Access Compliance Report

Public Rights-of-Way

(Curb Ramps)

Intersection ID: 31735	Main Street: RAISIN_TREE_LN	Cross Street: PAPER_BIRCH_DR	Location: E
ADA ID: 3A05554D7AD1	Ramp Type: PerpDiag	Initial Pass/Fail: Fail	Overall Compliance: No
Severity Score: 10			
Codes/Mitigation Info/Possible Solution		Field Measurements/Component Compliance

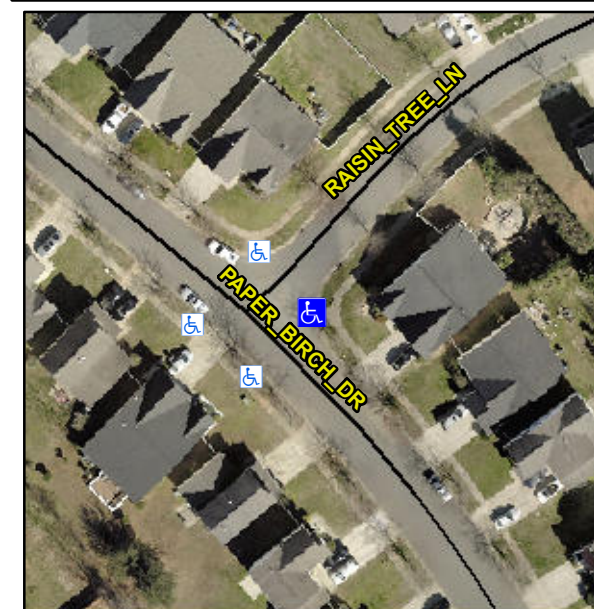
Not Found, R304.5.1, R304.5.3

Compliance	Description	Data	Compliance	Description	Data
N/A	Ramp Length (in)	84.0	Yes	Ramp Slope (%)	7.1
No	Ramp Width (in)	37.0	No	Ramp XSlope (%)	4.0
N/A	Flare Type LT	N/A	N/A	Flare Type RT	N/A
N/A	Flare Slope LT (%)	N/A	N/A	Flare Slope RT (%)	N/A
N/A	Flare Traversable LT?	N/A	N/A	Flare Traversable RT?	N/A
N/A	Landing Length (in)	N/A	N/A	DWS Provided?	N/A
N/A	Landing Width (in)	N/A	N/A	DWS Contrast?	N/A
N/A	Landing Slope (%)	N/A	N/A	DWS Length (in)	N/A
N/A	Landing X Slope (%)	N/A	N/A	DWS Full Width?	N/A
N/A	Landing Curb? (Y/N)	N/A	N/A	DWS Offset (in)	N/A
N/A	Shared Landing?	N/A			
N/A	Gutter Ponding?	N/A	N/A	Gutter Slope (%)	N/A
N/A	Gutter Lip Ht (in)	0.5	N/A	Gutter X Slope (%)	N/A
N/A	Painted X Walk1?	No	N/A	Painted X Walk2?	No
	X Walk 1 Direction	To NW		X Walk 2 Direction	To SW
N/A	X Walk 1 Width (in)	N/A	N/A	X Walk 2 Width (in)	N/A
	X Walk 1 Slope (%)	1.4		X Walk 2 Slope (%)	3.8
	X Walk 1 X Slope (%)	3.9		X Walk 2 X Slope (%)	2.4

Remove & Replace Curb Ramp With Two New Directional Ramps or Equivalent.
